ECFRPC DRI 5361
September 21, 2005

PLAZA COLLINA

Development of Regional Impact

Lake County

Figure 2 Master Plan

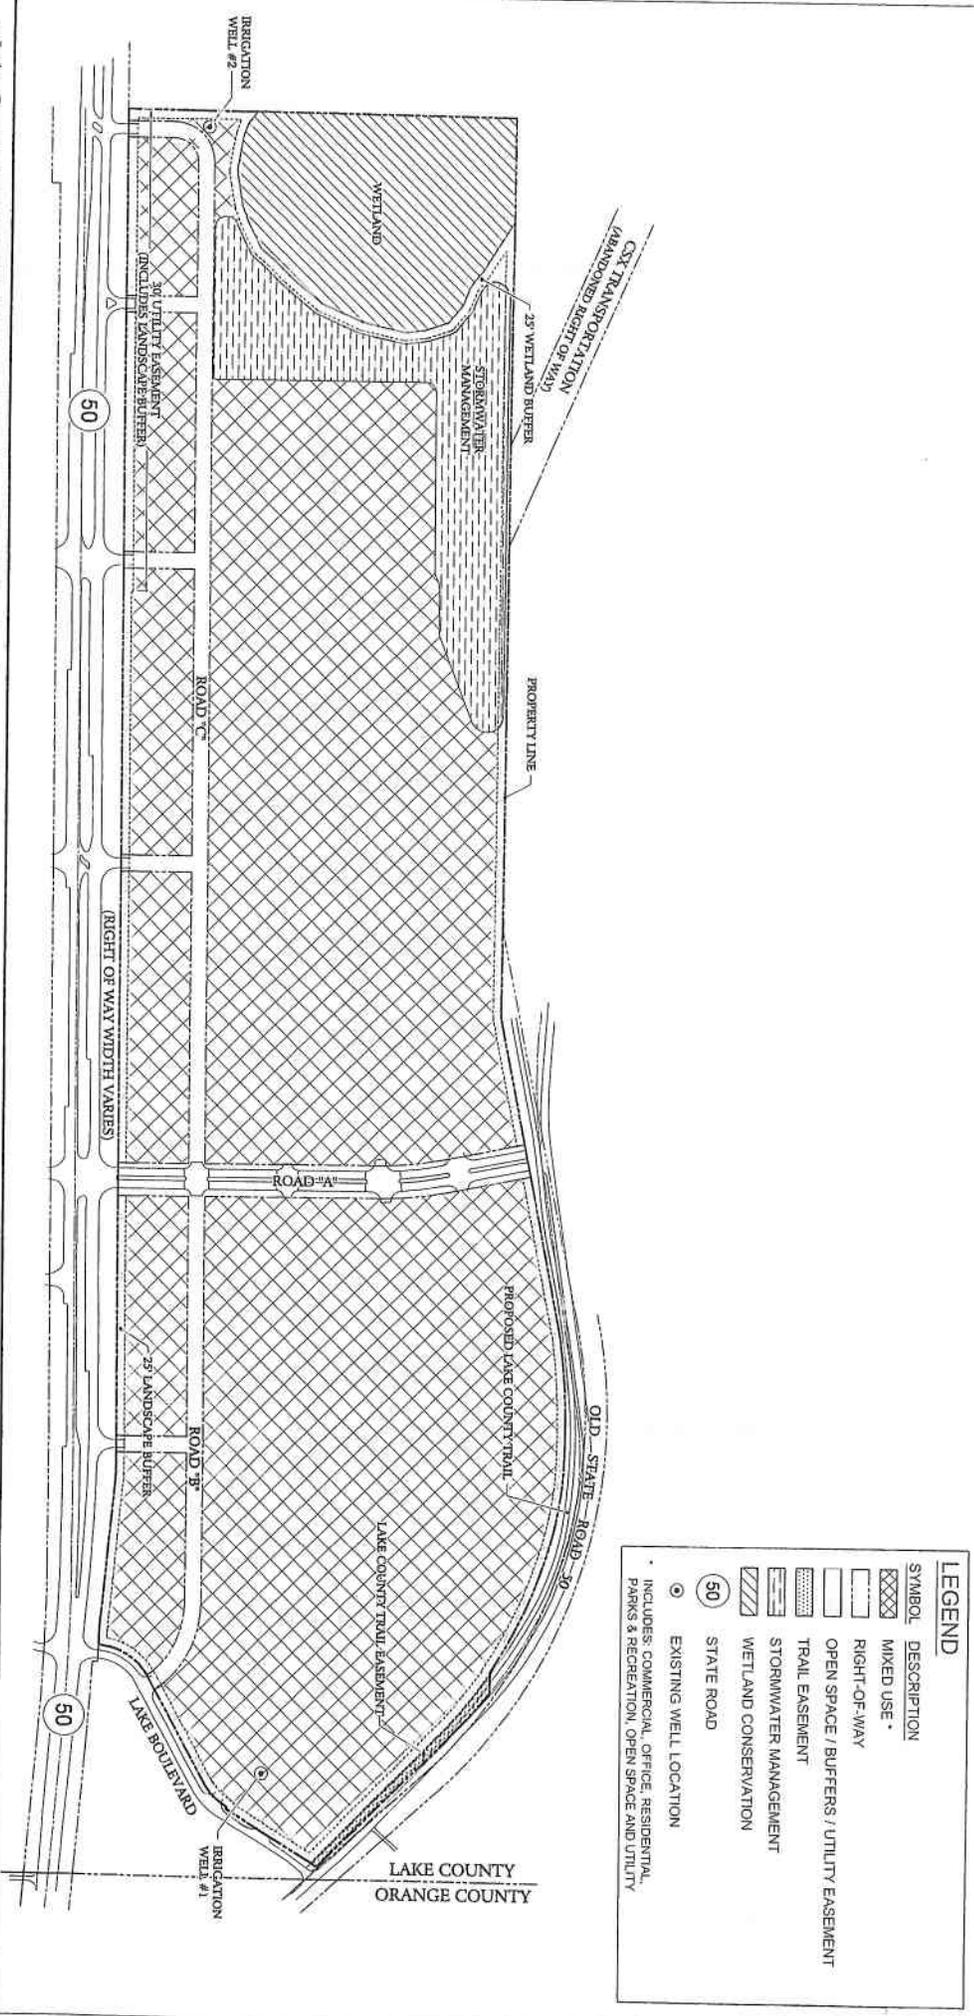
1. A plan for the entire area along the Scenic Byway from Deer Island Road to the west side of the DRI should be developed.
2. The Master Plan included in the ADA is not detailed enough for accurate analysis.

Figure 5 Suggested Roadway Realignment

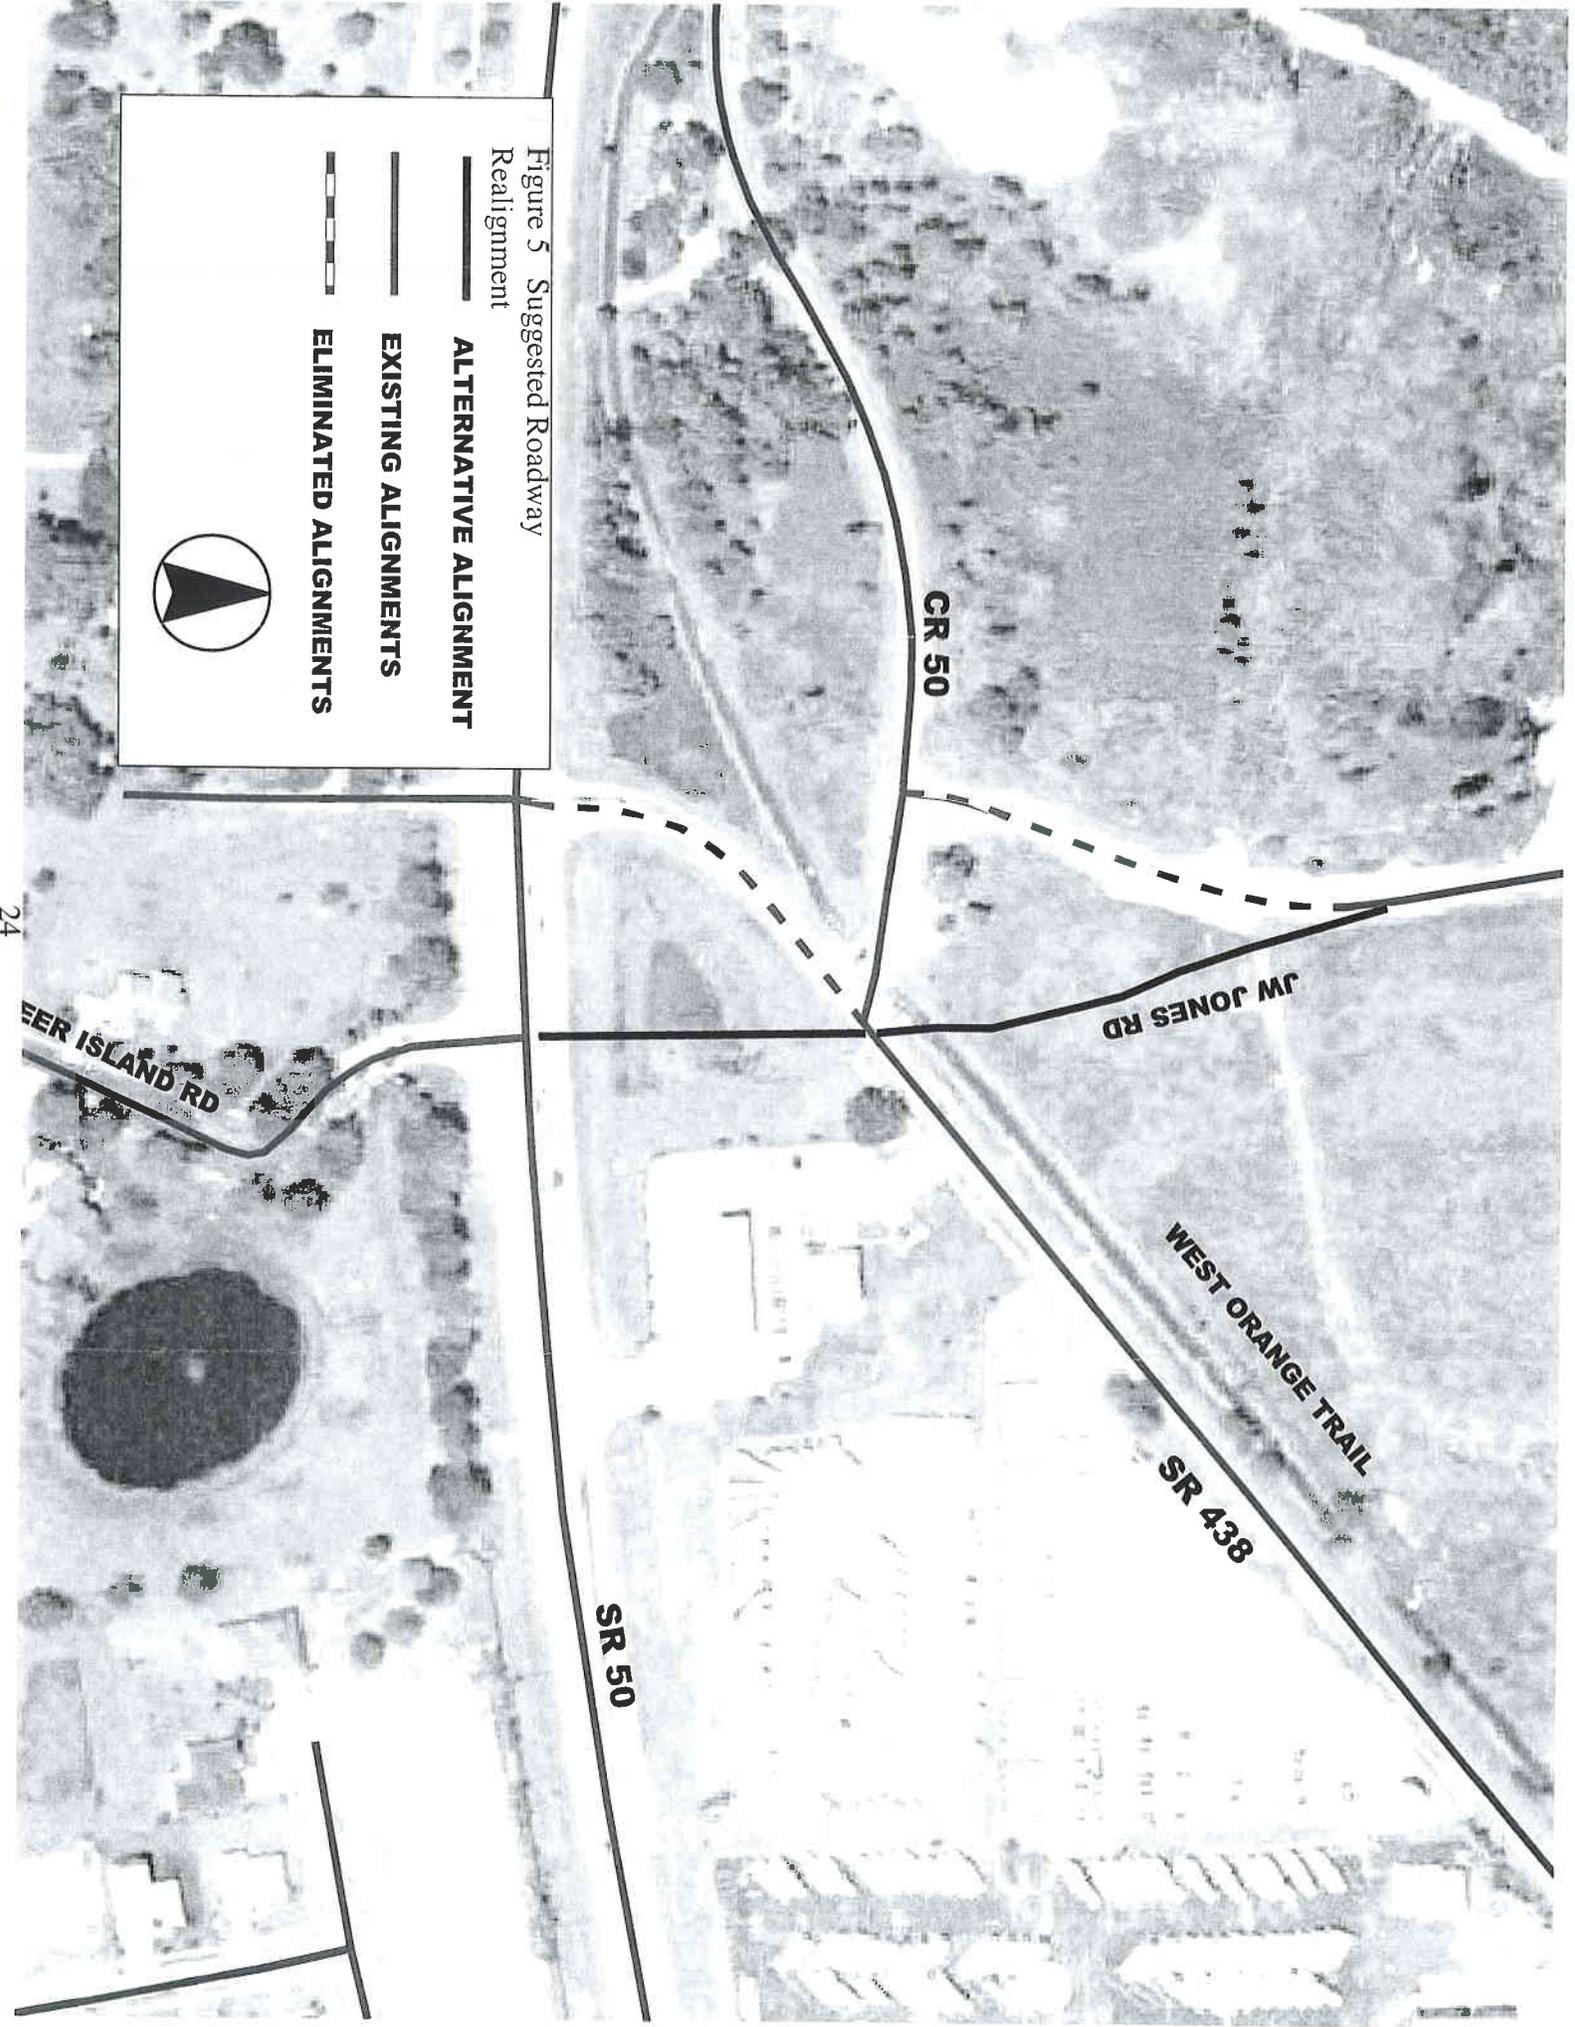
Further to the east and closer to the project site, the geometry of the roadway intersections is such that the intersections may be too close for signalization. The Town of Oakland has requested that the developer study the realignment of roadways in the area and, in particular, to see if the realignment as depicted in Figure 5 would work. A recommendation is include that this study be accomplished.
